Access Compliance Report

Public Rights-of-Way

Intersection ID: 30249	Main Street: BRADEN_DR	Cross Street: WINDING_BRANCH_CT	Location: E
ADA ID: ABD8210EC3FC	Ramp Type: BlendTrans2	Initial Pass/Fail: Pass	Overall Compliance: No
Severity Score: 10.25			
Codes/Mitigation Info/Possible Solution		Field Measurements/Component Compliance

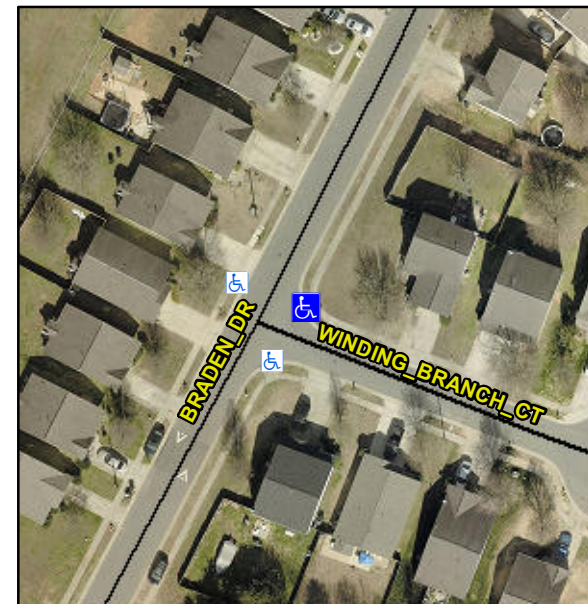
Not Found, R304.5.3, R305

Compliance	Description	Data	Compliance	Description	Data
N/A	Ramp Length (in)	97.0	Yes	BlendTrans Slope (%)	1.5
Yes	Ramp Width (in)	60.0	No	BlendTrans XSlope (%)	3.4
N/A	Flare Type LT	Sloped	N/A	Flare Type RT	Sloped
N/A	Flare Slope LT (%)	4.9	N/A	Flare Slope RT (%)	4.8
N/A	Flare Traversable LT?	No	N/A	Flare Traversable RT?	No
N/A	Landing Length (in)	N/A	No	DWS Provided?	No
N/A	Landing Width (in)	N/A	N/A	DWS Contrast?	No
N/A	Landing Slope (%)	N/A	N/A	DWS Length (in)	N/A
N/A	Landing X Slope (%)	N/A	N/A	DWS Full Width?	No
N/A	Landing Curb? (Y/N)	No	N/A	DWS Offset (in)	N/A
N/A	Shared Landing?	No			
Yes	Gutter Ponding?	No	Yes	Gutter Slope (%)	3.0
Yes	Gutter Lip Ht (in)	0.0	Yes	Gutter X Slope (%)	1.1
N/A	Painted X Walk1?	No	N/A	Painted X Walk2?	No
	X Walk 1 Direction	To NW		X Walk 2 Direction	To SW
	X Walk 1 Width (in)	N/A		X Walk 2 Width (in)	N/A
	X Walk 1 Slope (%)	2.2		X Walk 2 Slope (%)	3.3
	X Walk 1 X Slope (%)	2.5		X Walk 2 X Slope (%)	3.2

N/A	Ramp inside XWalk1?	N/A	N/A	Ramp inside XWalk2?	N/A
	Road Slope (%)	0.6		Clear Space?	Yes
	Road X Slope (%)	3.5	N/A	Clear Space to XWalk (in)	N/A
Yes	Any Obstructions?	No	Yes	Storm Grate/Utility Hazard?	No
	Obstruction Type			Storm Grate/Utility Type	
		N/A			N/A
			Yes	Surface Condition? (G/P)	Good
			No	Curb Slope (%)	11.3

Remove & Replace Curb Ramp With Two New Directional Ramps or Equivalent.
